Applicant : Vinay K. Awasthi
Serial No. : 09/753,083
Filed : December 28, 2000
Page : 16 of 16

Attorney's Docket No.: 10559-373001 / P10179

Amendments to the Drawings:

FIG. 2

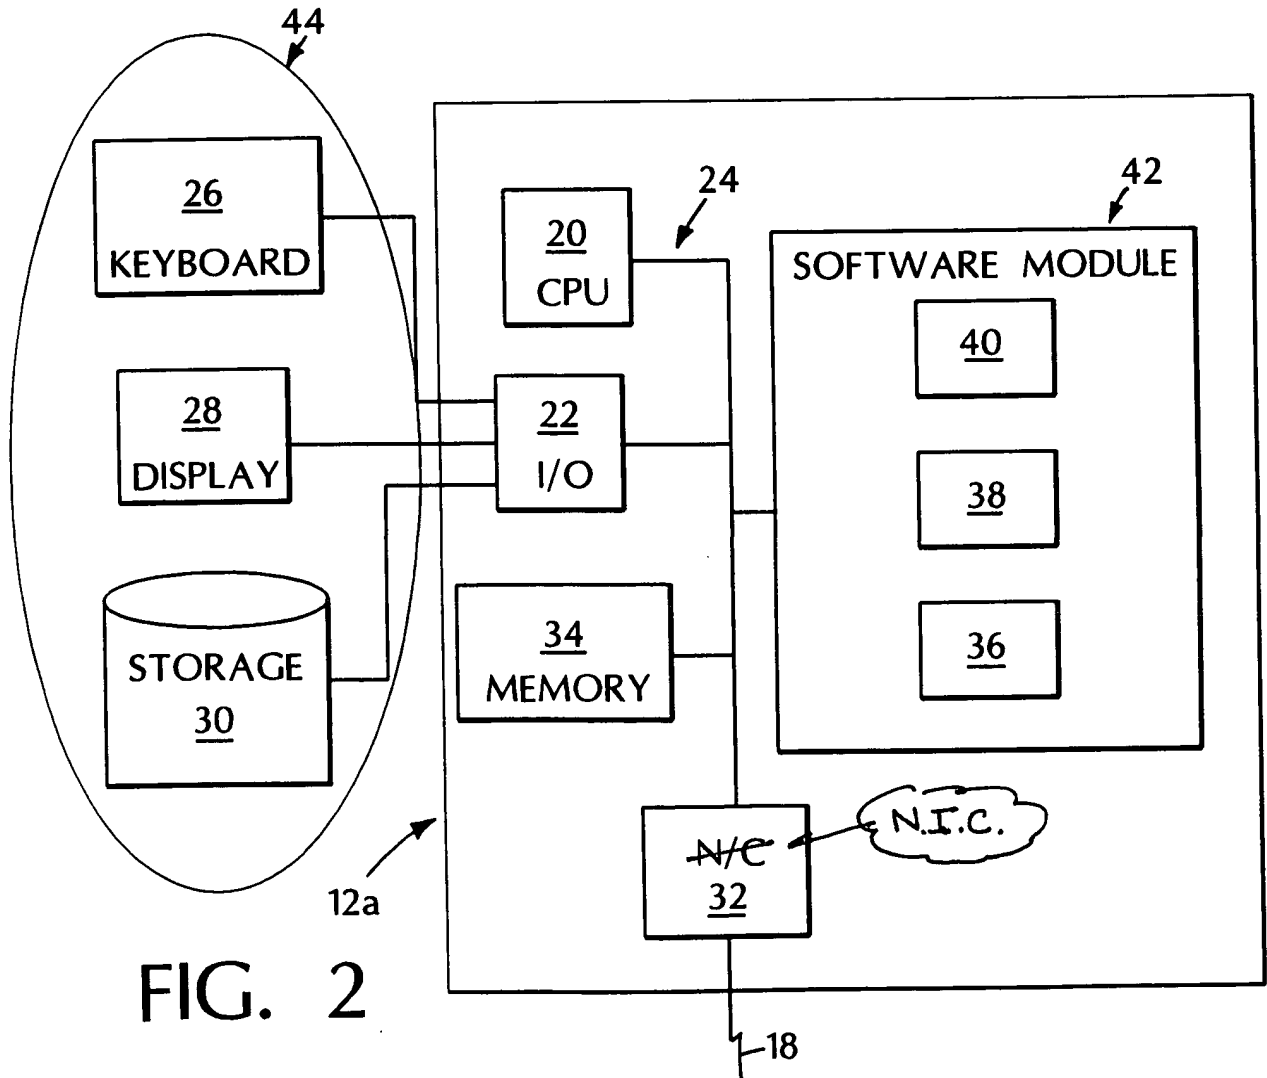
Fig. 2 was objected to because element 32 should be labeled “NIC,” not “N/C.” Fig. 5 was objected to because step 170 should read “Receive data packets from device.” Fig. 5 also was objected to because step 180 should read “Transfer Data Packets to Program.” Applicant has corrected each of these clerical errors. Two replacement sheets showing these corrections are attached.

In Figure 2, "N/C" in the box labeled 32 has been changed to "NIC."
